Rowan

Site Specific Flood Risk Assessment

Coffey Construction Ltd, Slade, Saggart,
Co. Dublin

Date: 14th December 2021 – REV.C

DRAWING NO:
 Figure 5.

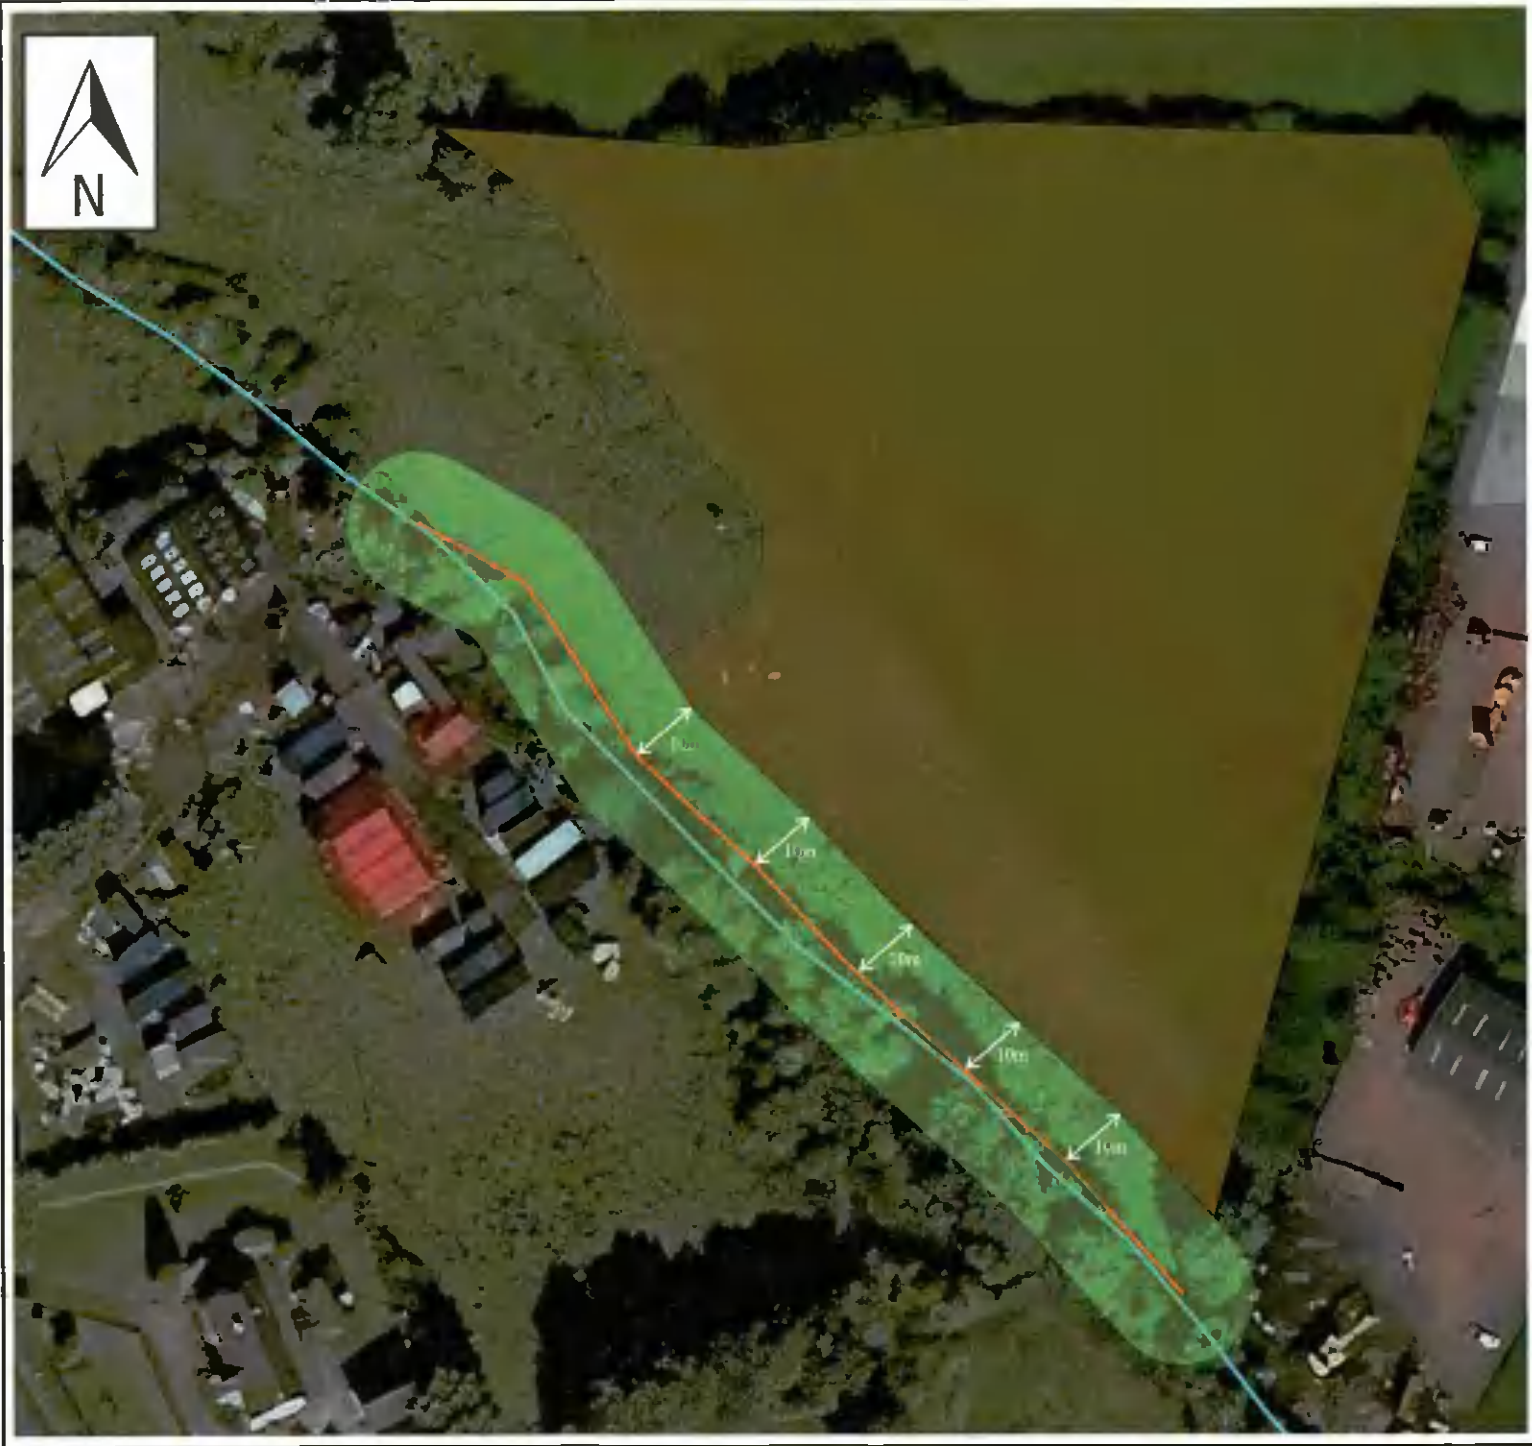
Please see Figure 7 included within this report. A minimum setback back distance of 10m from the edge of the infill area and the top of the riverbank has been achieved. Please also note that given the infill area has been reduced, Figure 5 has also been amended to account for this.

- An area of compensatory storage should be developed within the western portion of the site. Figure 5 shows how this area is hydraulically linked to the existing 1 in 100-year flood plain and to what elevation, the ground should be lowered too. As is demonstrated on Figure 5, this proposed compensation area is outside of the 1% AEP (plus climate change allowance) Flood Zone. It is appropriate to partially position this compensation area within the 10m set back buffer zone as no infilling will occur and the area will still act as a buffer zone during the infilling activities. Figure 7, demonstrates how a 10m set back distance of 10m from the edge of the infill area to the river bank will be achieved.
